<b>Subject:</b>  RATTLE NOISE FROM PASSENGER SIDE DASHBOARD	<b>Bulletin No:</b> 09-008/13
	<b>Last Issued:</b> 03/21/2013

## APPLICABLE MODEL(S)/VINS

2014 Mazda6 vehicles with VINs lower than JM1 GJ \*\*\*\*\* 109218 (produced before February 4, 2013)

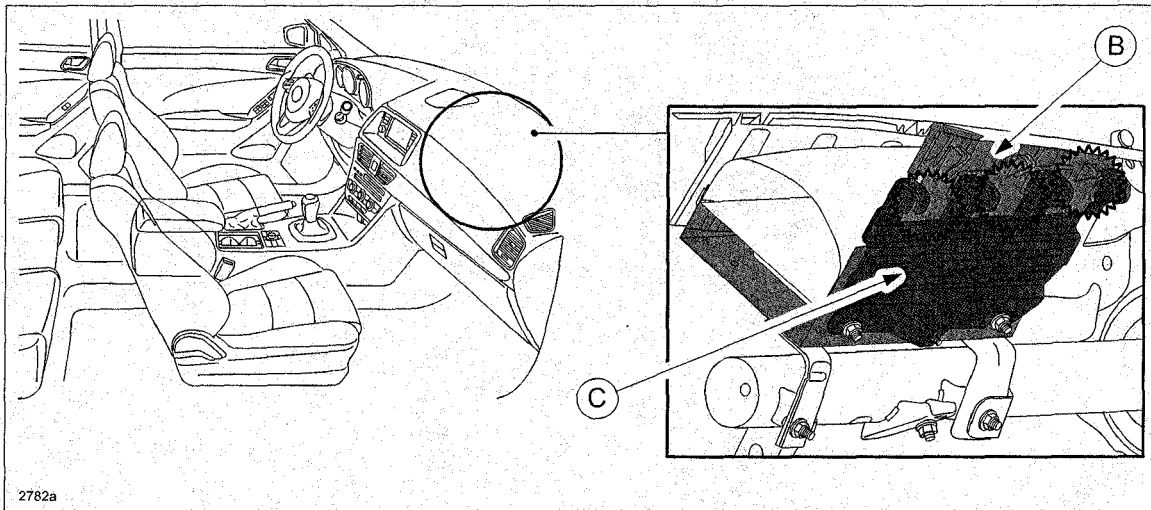
This noise may be caused by the passenger-side air bag module bracket (C) contacting the bracket holder (B) when driving on a rough road.

Add non-woven fabric between the passenger-side air bag module bracket and the bracket holder.
